Licence Number	L8937/2015/1
Licensee	Pilbara Ports Authority (ABN 94 987 448 870)
Registered business address	The Esplanade PORT HEDLAND WA 6721
Duration	22/08/2016 to 21/08/2036
Prescribed Premises	Category 58 Bulk material loading or unloading: premises on which clinker, coal, ore, ore concentrate or any other bulk granular material (other than salt) is loaded onto or unloaded from vessels by an open materials loading system.
Premises	Utah Point Multi-User Bulk Handling Facility Utah Point, Finucane Island, WA, 6721, PORT HEDLAND Portion of LOT 370 on Plan 35619

Applicant:	Pilbara Ports Authority
ACN/ABN:	94 987 448 870
Licence Number:	L8937/2015/1
File Number:	DER2015/002837
Premises:	Utah Point Multi-User Bulk Handling Facility Portion of Lot 370 on Plan 35619 PORT HEDLAND, WA 6721 Certificate of Title Volume LR3118 Folio 753
Date of report:	Thursday, 18 August 2016
Status of Report	Final

The applicant was provided with the draft decision report and draft licence on 10 March 2016 for review and comment and then again on 30 May 2016. The applicant provided a number of comments during both consultation periods which have been considered and are tabled through Appendix 3.

Premises Map

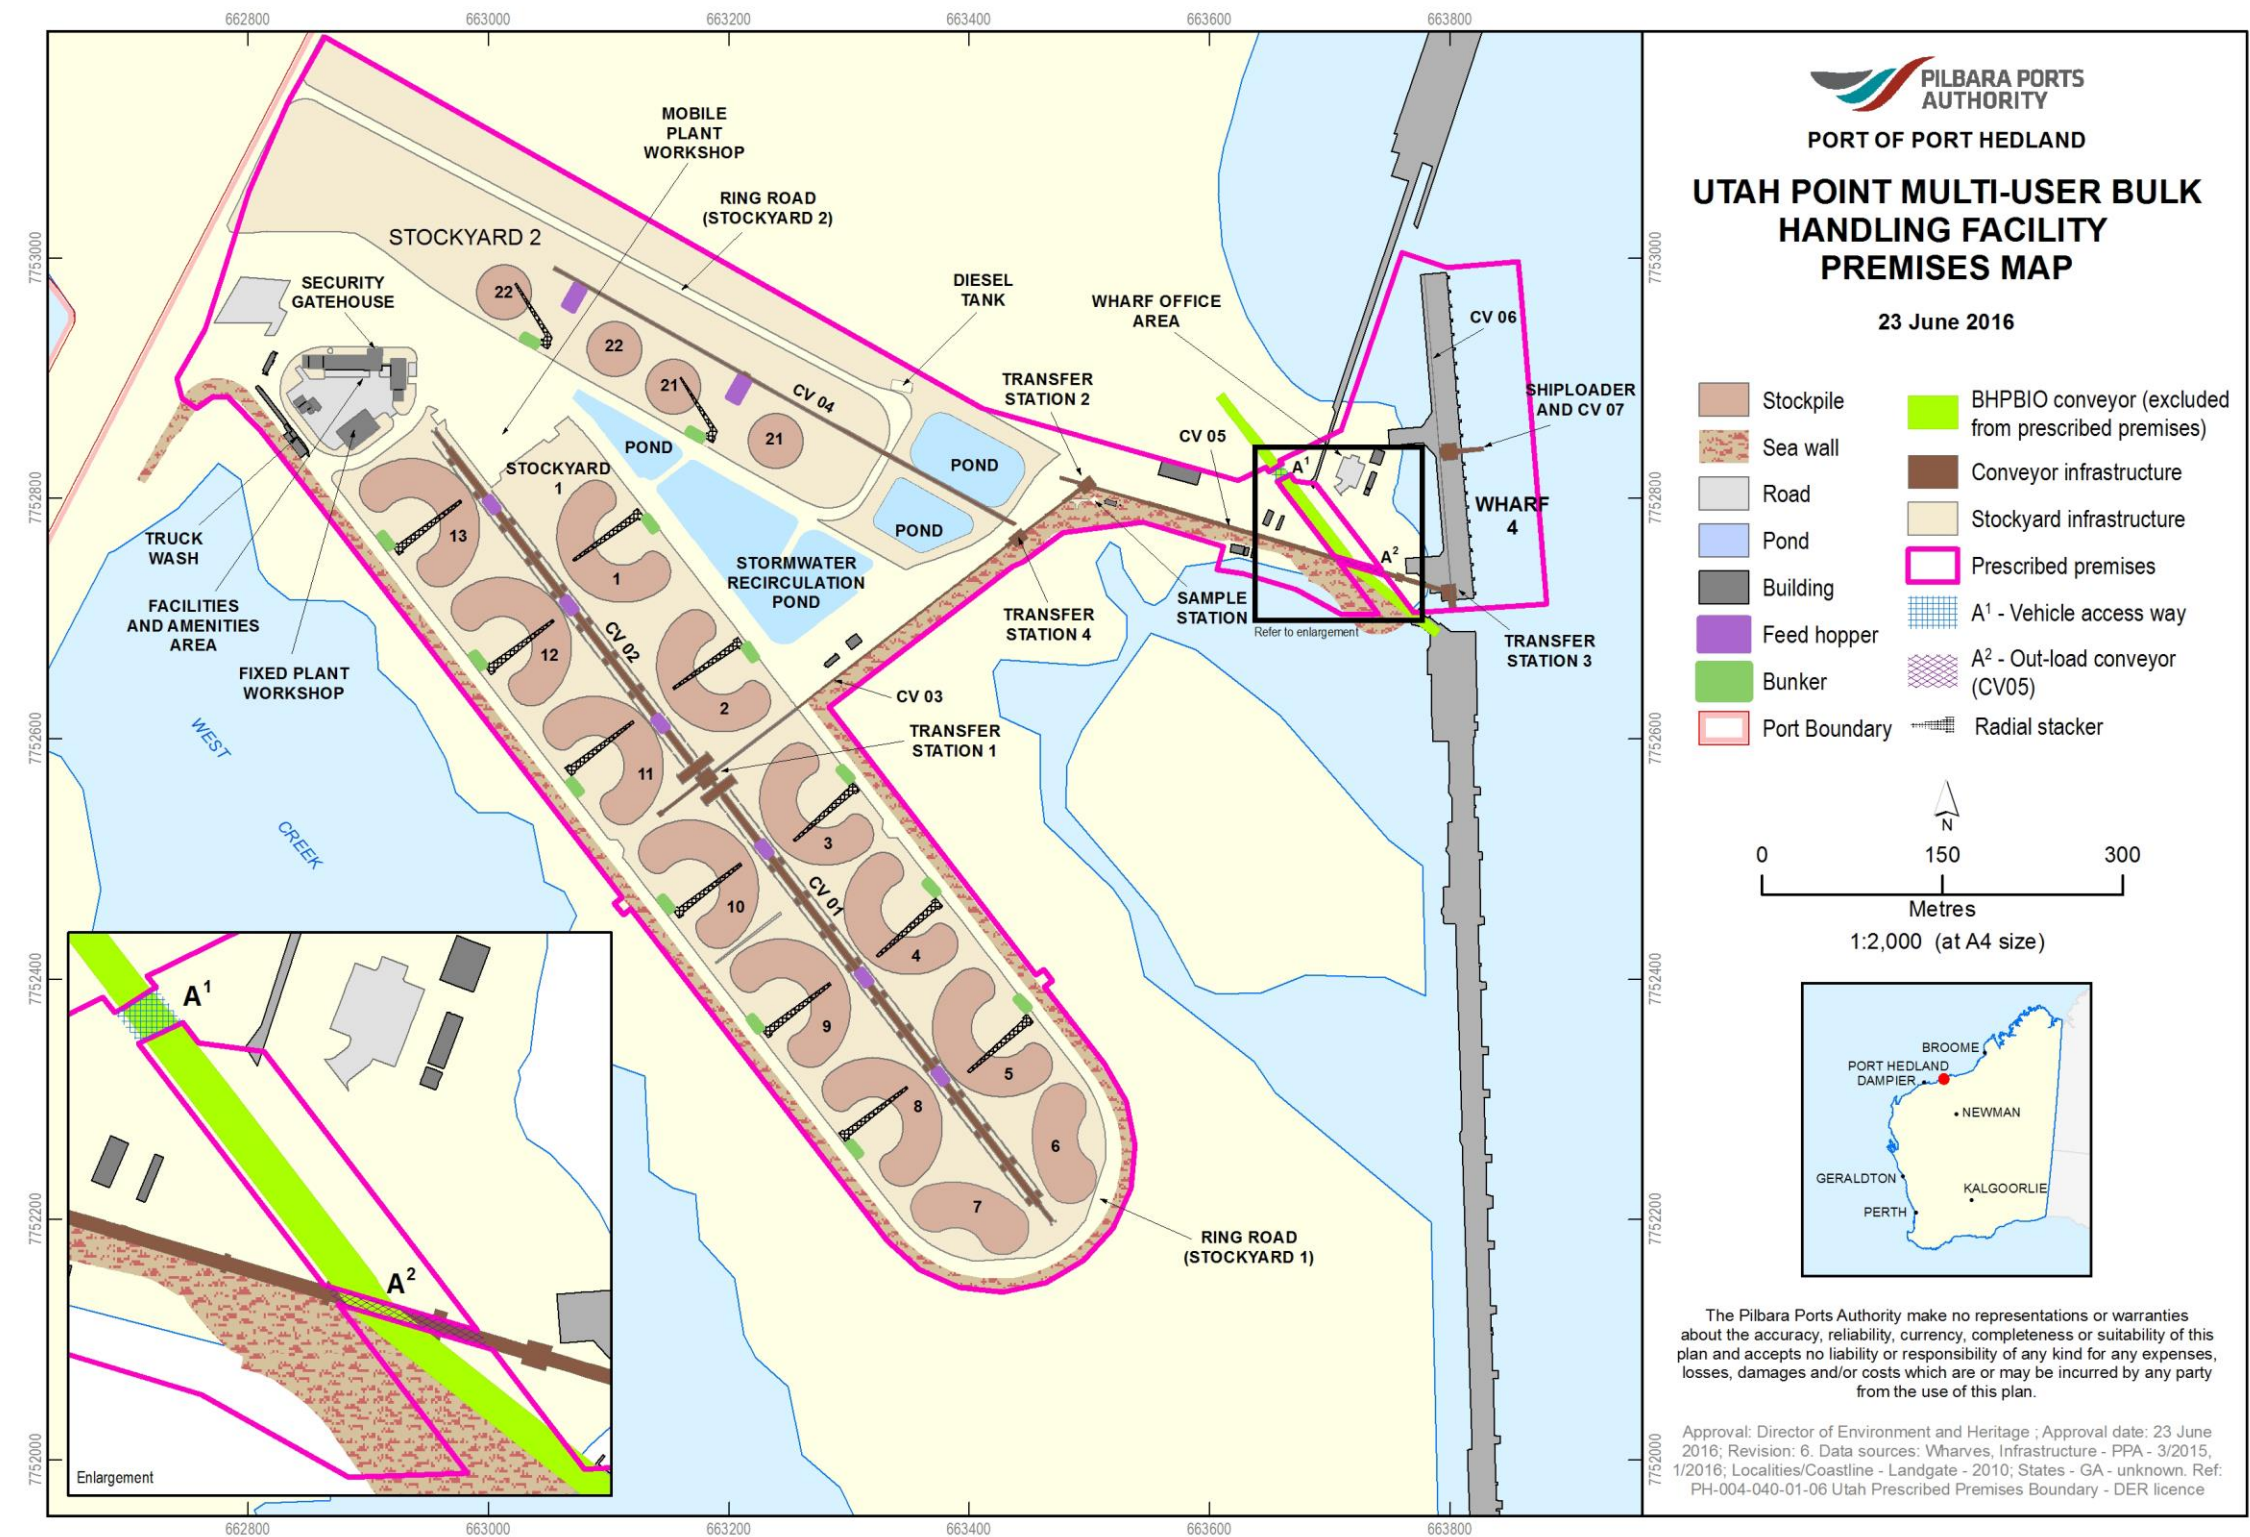
20.	Applicants comment.	An updated premise map is provided in Attachment 4 to this letter.
	DER Response	Noted, updated map used.
